Access Compliance Report

Public Rights-of-Way

(Curb Ramps)

Intersection ID: 49797	Main Street: ATKINS_RIDGE_DR	Cross Street: PARSIFAL_LN	Location: S
ADA ID: 05687AD57BC1	Ramp Type: PerpDiag	Initial Pass/Fail: Fail	Overall Compliance: No
Severity Score: 21.25			
Codes/Mitigation Info/Possible Solution		Field Measurements/Component Compliance

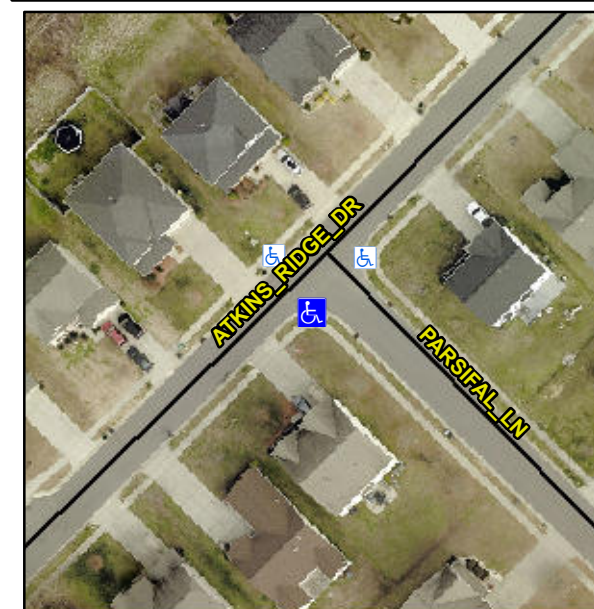
Not Found, R304.5.1, R304.5.3

Compliance	Description	Data	Compliance	Description	Data
N/A	Ramp Length (in)	47.0	Yes	Ramp Slope (%)	6.9
No	Ramp Width (in)	47.0	No	Ramp XSlope (%)	5.8
N/A	Flare Type LT	N/A	N/A	Flare Type RT	N/A
N/A	Flare Slope LT (%)	N/A	N/A	Flare Slope RT (%)	N/A
N/A	Flare Traversable LT?	N/A	N/A	Flare Traversable RT?	N/A
N/A	Landing Length (in)	N/A	N/A	DWS Provided?	N/A
N/A	Landing Width (in)	N/A	N/A	DWS Contrast?	N/A
N/A	Landing Slope (%)	N/A	N/A	DWS Length (in)	N/A
N/A	Landing X Slope (%)	N/A	N/A	DWS Full Width?	N/A
N/A	Landing Curb? (Y/N)	N/A	N/A	DWS Offset (in)	N/A
N/A	Shared Landing?	N/A			
N/A	Gutter Ponding?	N/A	N/A	Gutter Slope (%)	N/A
N/A	Gutter Lip Ht (in)	N/A	N/A	Gutter X Slope (%)	N/A
N/A	Painted X Walk1?	No	N/A	Painted X Walk2?	No
	X Walk 1 Direction	To NE		X Walk 2 Direction	To NW
N/A	X Walk 1 Width (in)	N/A	N/A	X Walk 2 Width (in)	N/A
	X Walk 1 Slope (%)	4.3		X Walk 2 Slope (%)	3.6
	X Walk 1 X Slope (%)	0.5		X Walk 2 X Slope (%)	5.9

N/A	Ramp inside XWalk1?	N/A	N/A	Ramp inside XWalk2?	N/A
	Road Slope (%)	2.9	N/A	Clear Space?	N/A
	Road X Slope (%)	6.4	N/A	Clear Space to XWalk (in)	N/A
N/A	Any Obstructions?	N/A	N/A	Storm Grate/Utility Hazard?	N/A
	Obstruction Type			Storm Grate/Utility Type	
		N/A			N/A
		Yes		Surface Condition? (G/P)	Good

Remove & Replace Curb Ramp With Two New Directional Ramps or Equivalent.
